UNITED STATES
NUCLEAR REGULATORY COMMISSION
WASHINGTON, D. C. 20555

The Commission has issued the enclosed Amendments Nos. 81, 81, and 78 for Licenses Nos. DPR-38, DPR-47, and DPR-55 for the Oconee Nuclear Station, Units Nos. 1, 2, and 3. These amendments consist of changes to the Station's common Technical Specifications and are in response to your request dated August 6, 1979, as supplemented August 22, 1979, December 31, 1979, and January 28, 1980.

These amendments revise the Technical Specifications to support the operation of Oconee Unit No. 1 at full rated power during Cycle 6. The amendments also revise the Technical Specifications for Units Nos. 1, 2, and 3 in regard to engineered safety features.

ATTACHMENTS TO LICENSE AMENDMENTS

CORE PROTECTION
SAFETY LIMITS
UNIT 1
OCONEE NUCLEAR STATION
Figure 2.1-2A

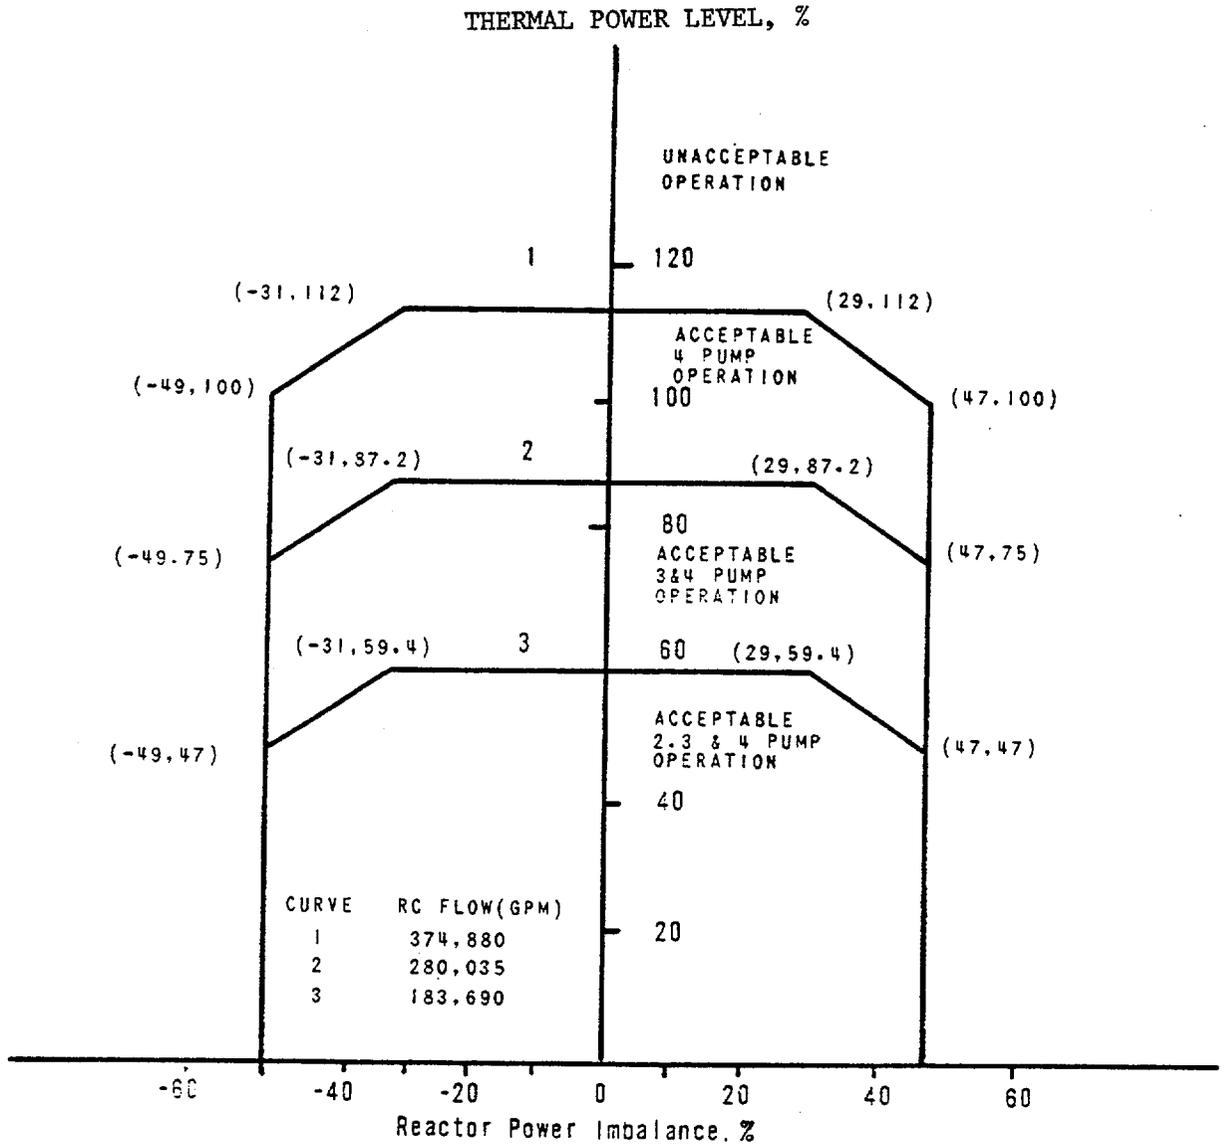
The curves of Figure 2.1-2A are based on the more restrictive of two thermal limits and include the effects of potential fuel densification and rod bowing:

1. The 1.30 DNBR limit produced by the combination of the radial peak, axial peak and position of the axial peak that yields no less than a 1.30 DNBR.
2. The combination of radial and axial peak that causes central fuel melting at the hot spot. The limit is 20.05 kw/ft for Unit 1. (3)

The specified flow rates for Curves 1, 2, and 3 of Figure 2.1-2A correspond to the expected minimum flow rates with four pumps, three pumps, and one pump in each loop, respectively.

PROTECTIVE SYSTEM
 MAXIMUM ALLOWABLE SETPOINTS
 UNIT 1
 OCONEE NUCLEAR STATION
 Figure 2.3-2A

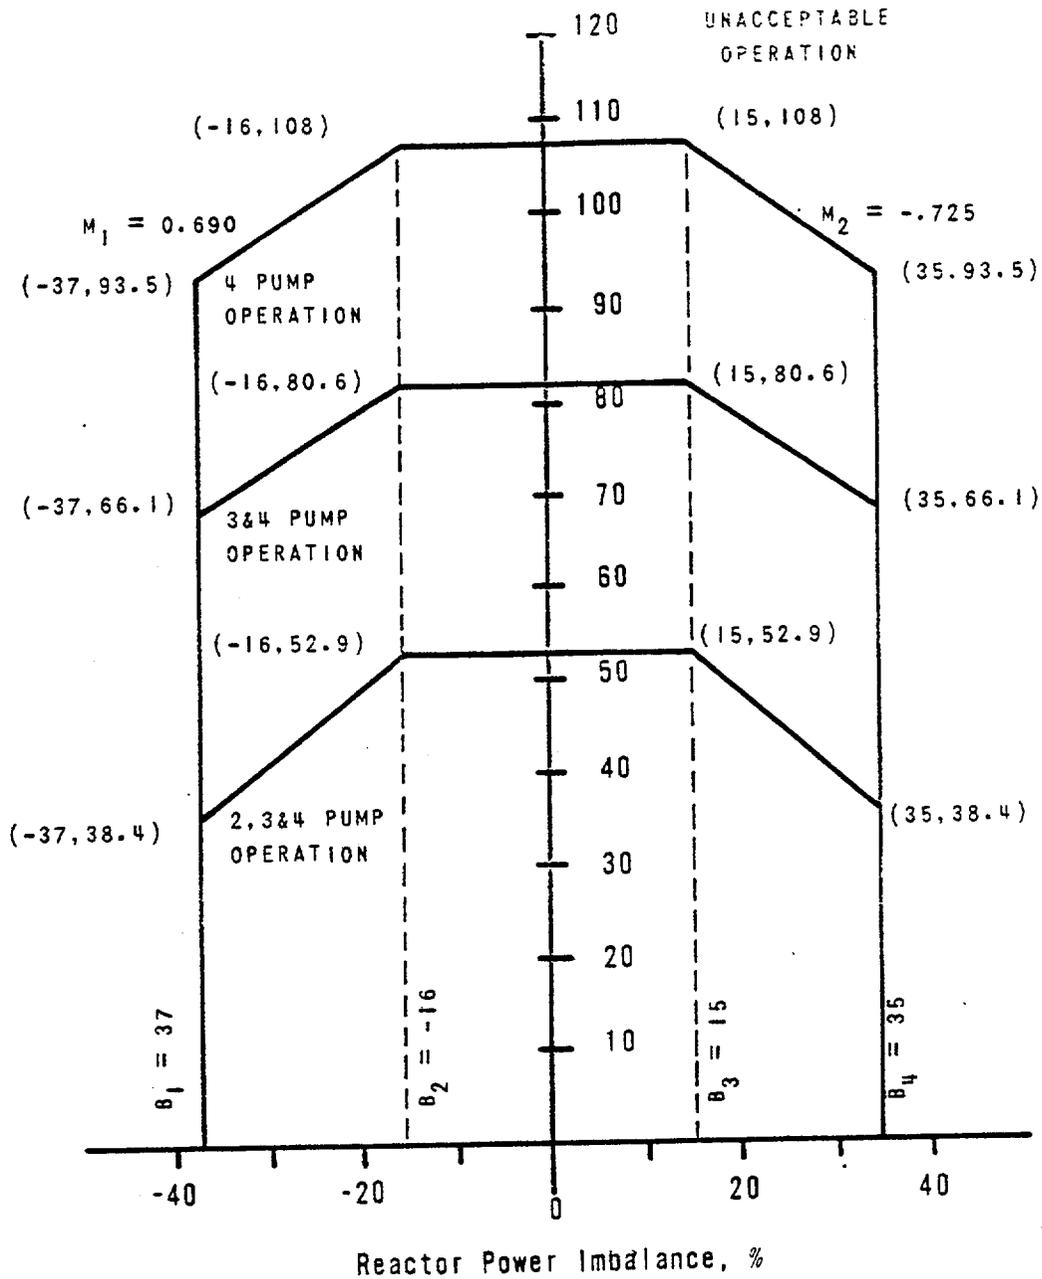
The power-imbalance boundaries are established in order to prevent reactor thermal limits from being exceeded. These thermal limits are either power peaking kw/ft limits or DNBR limits. The reactor power imbalance (power in the top half of core minus power in the bottom half of core) reduces the power level trip produced by the power-to-flow ratio such that the boundaries of Figure 2.3-2A - Unit 1 are produced. The power-to-flow ratio reduces the power

level trip and associated reactor power/reactor power-imbalance boundaries by 1.08% - Unit 1 for 1% flow reduction.
